8563EC-04

S E R V I C E N O T E

856xEC Series Portable Spectrum Analyzer

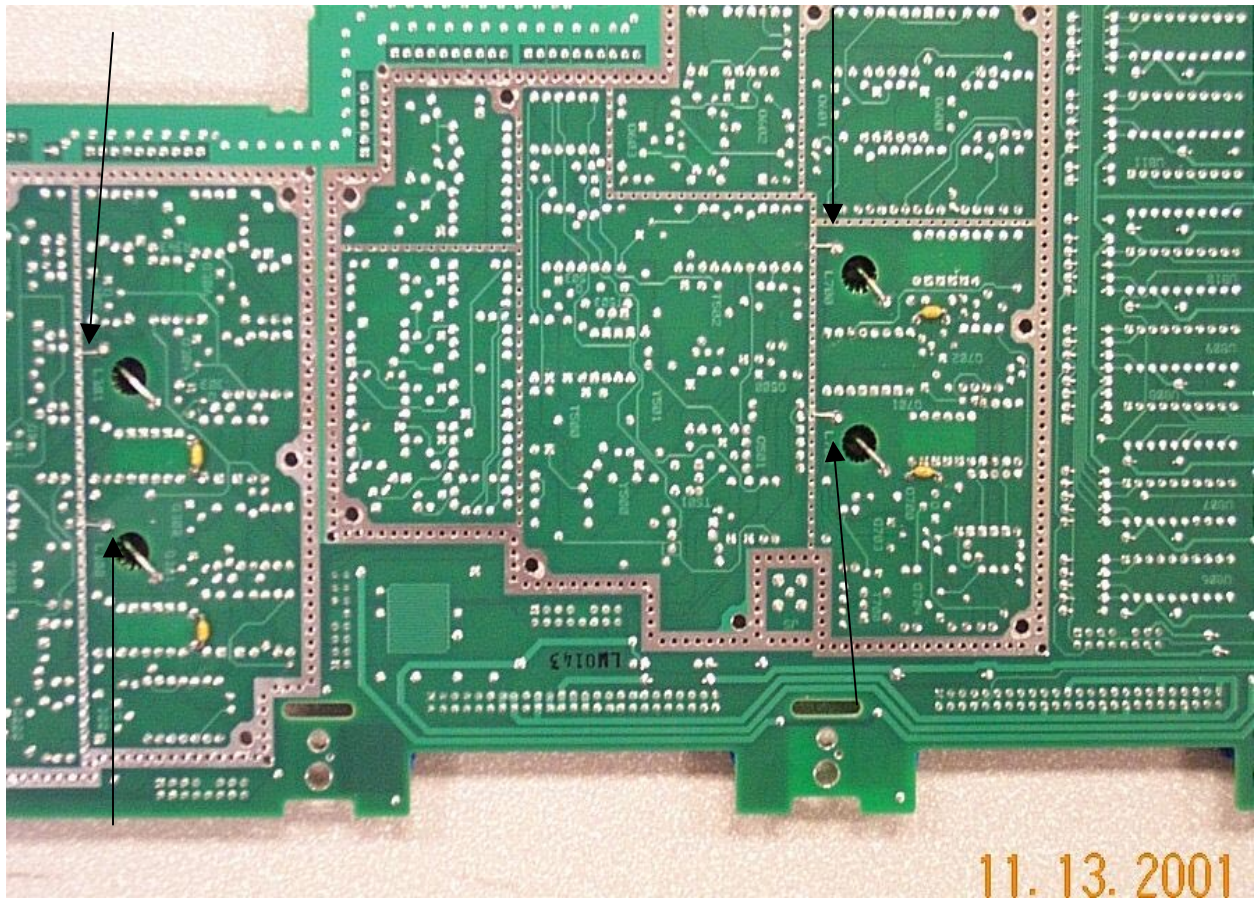
For the instruments specified above, inductors within the A5 IF assembly are not making good connections to ground thereby giving error messages related to the A4 Log Amp board. Error numbers that appear in the lower right-hand corner of the screen on account of this problem are errors 561, 562, and 565.

If the serial number of the instrument applies to the ones above, the following butch may solve the problem. Remove the shielding from the A5 IF assembly. Locate the inductors, and according to the attached photograph, insert and solder one end of the 8150-4222 wire into the hole connecting to the inductors and solder the other end to the ground plane on the front layer of the board. Do this for each inductor. See attached picture, the arrows point to where the jumpers are attached.

Add jumpers according to the picture above.
